Pre-Preliminary Plan No. 720130110, Wheaton Woods

Completed: 10/25/13

Description

Figure 4: Recommended Off-site Sidewalk Improvement Area

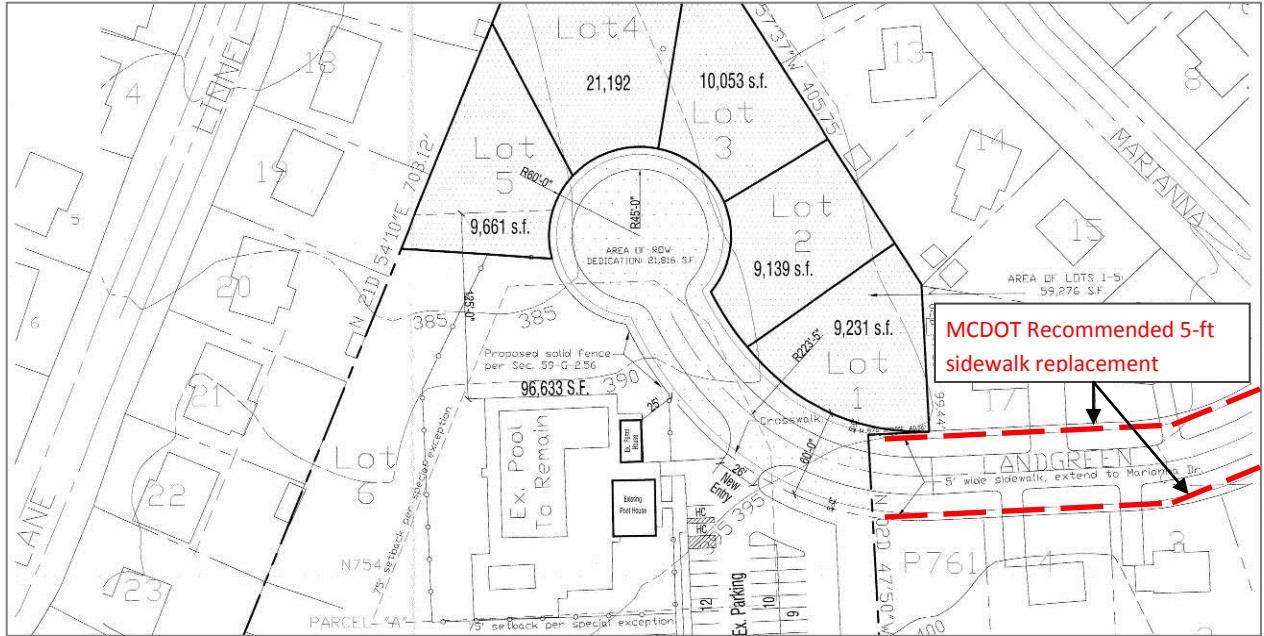
The Montgomery County Department of Transportation (MCDOT) has recommended that the Applicant bring the existing four-foot wide sidewalks along Landgreen Street from the proposed development to Marianna Drive up to ADA standards (see Figure 4 on the following page). Recommendations to accomplish this include replacing the existing four-foot wide sidewalks with new five-foot sidewalks with ADA curb ramps at the intersection, or provide apron areas within the public right-of-way. The existing four-foot wide sidewalks along Landgreen Street are in good condition (see Images 1 and 2 on the following page) and are representative of the sidewalk network within the immediate neighborhood, and numerous existing driveways may serve the purpose of the aprons. For these reasons, the applicant does not agree with the MCDOT recommendation to replace the existing four-foot sidewalks with five-foot sidewalks. Staff agrees that requiring the Applicant to tear up the existing sidewalks to widen them to five-feet would be an unnecessary burden given the condition of the sidewalks and the existing sidewalk network throughout the neighborhood.

Staff supports the proposed six-lot resubdivision. The subdivision is consistent with the character of lots and pattern of the surrounding neighborhood. With regard to the replacement of the existing sidewalks from the eastern edge of the proposed subdivision on Landgreen Street to Marianna Drive, Staff concurs with the Applicant that the existing sidewalks are in good to excellent condition. Staff believes that requiring the Applicant to replace them with five-foot wide sidewalks would be an unnecessary burden given the condition of the sidewalks and the existing sidewalk network in the neighborhood is of four-foot wide sidewalks. Staff would support the installation of five-foot wide sidewalks for the proposed development's frontage tying into the existing four-foot wide sidewalks on Landgreen Street.

Figure 5: Surrounding Neighborhood

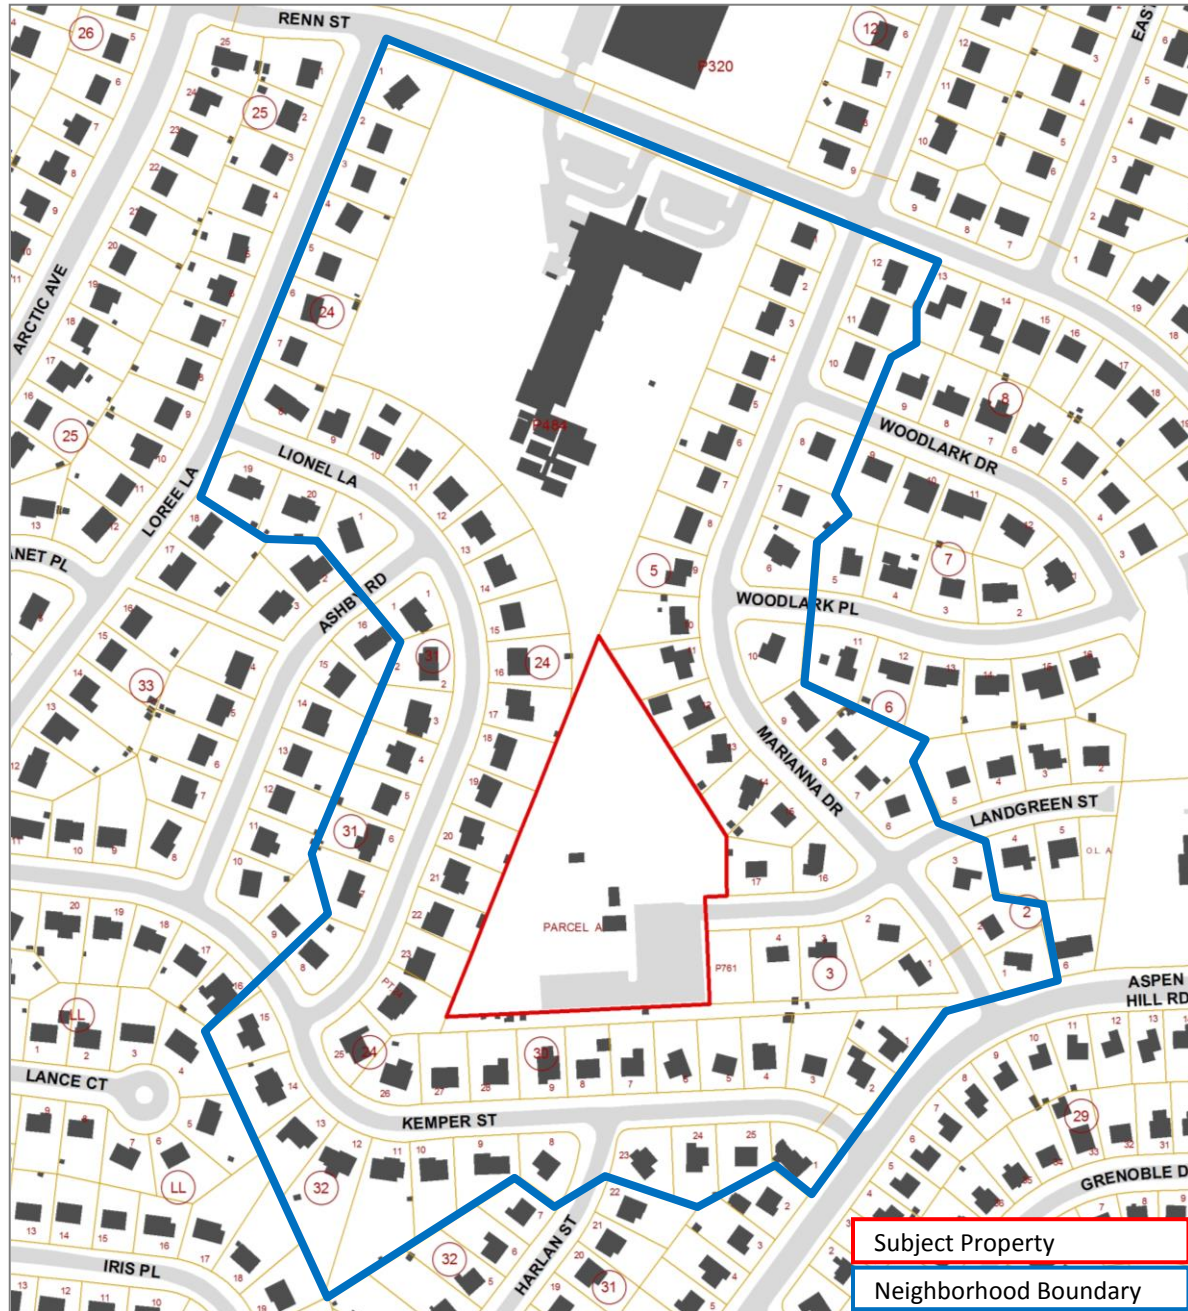
In administering §50-29(b)(2) of the Subdivision Regulations, the Planning Board must determine the appropriate “neighborhood” for evaluating an application. In this instance, the neighborhood defined by the Applicant, and agreed to by staff, consists of 96 lots and includes lots fronting on Marianna Drive, Kemper Street, Lionel Lane, and Loree Lane (see Figure 5). All of the lots in the defined neighborhood are zoned R-90, and provide an adequate sample and development pattern of the area.

SHEET TITLE / SCALE: Pre-Preliminary Plan

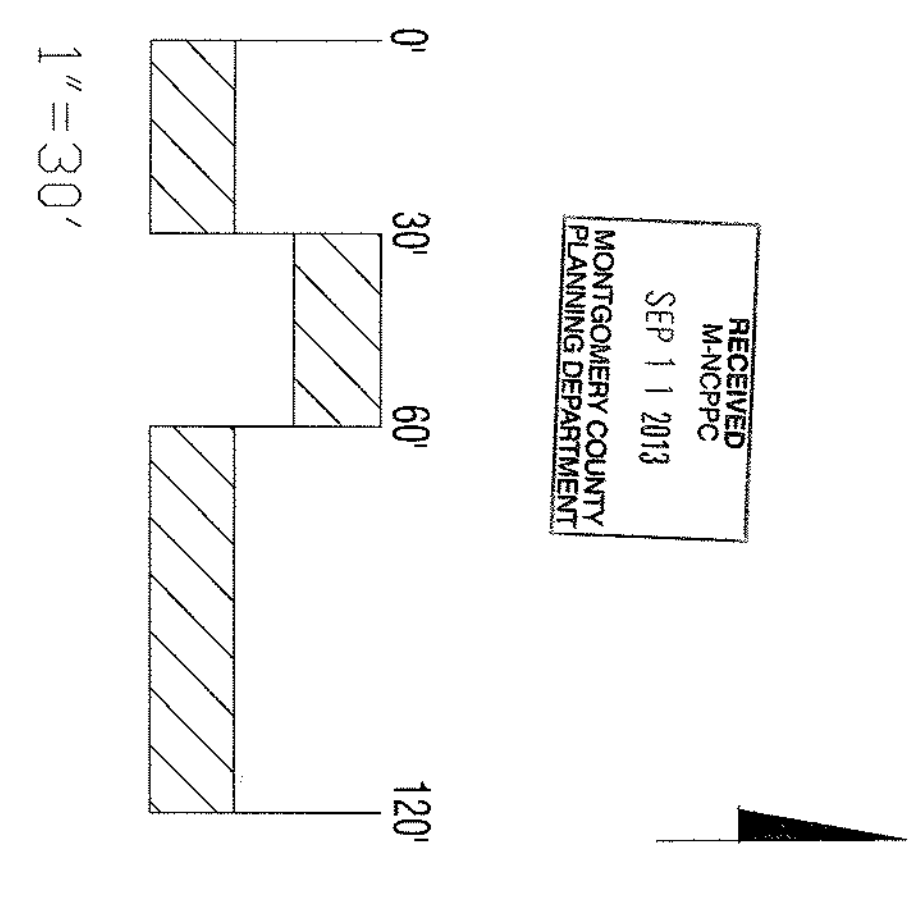
Section 50-29(a)(2) of the Subdivision Regulations requires street frontage in a resubdivision to be in character with the size of existing lots in the neighborhood. Proposed lot 3 would create the smallest street frontage within the delineated neighborhood (59 feet compared to the current smallest street frontage of 60 feet). Staff recommends that, if feasible, the applicant adjust proposed lot lines to maintain consistency with the existing neighborhood frontages that range between 60 and 245 feet. If that is not feasible, the applicant may request a waiver from the Planning Board pursuant to Section 50-38.

Frontage: Street frontages of the existing lots range from 60 feet to 245 feet. Thirteen of the existing lots have frontage of 69 feet or less, fifty-two of the lots have frontage between 70 feet and 100 feet, while the remaining thirty-one of the existing lots have frontage greater than 100 feet. **The street frontages for the proposed single-family lots range from 59 feet to 138 feet. The proposed layout would create one lot with the smallest street frontage in the delineated neighborhood.**

- The second issue pertains to the street frontage of new lots. One of the proposed lots would create the smallest street frontage in the neighborhood (59 feet compared to the existing smallest frontage of 60 feet). Staff believes that either a lot line adjustment to bring this frontage to 60 feet or a waiver per Section 50-38 can address this issue.
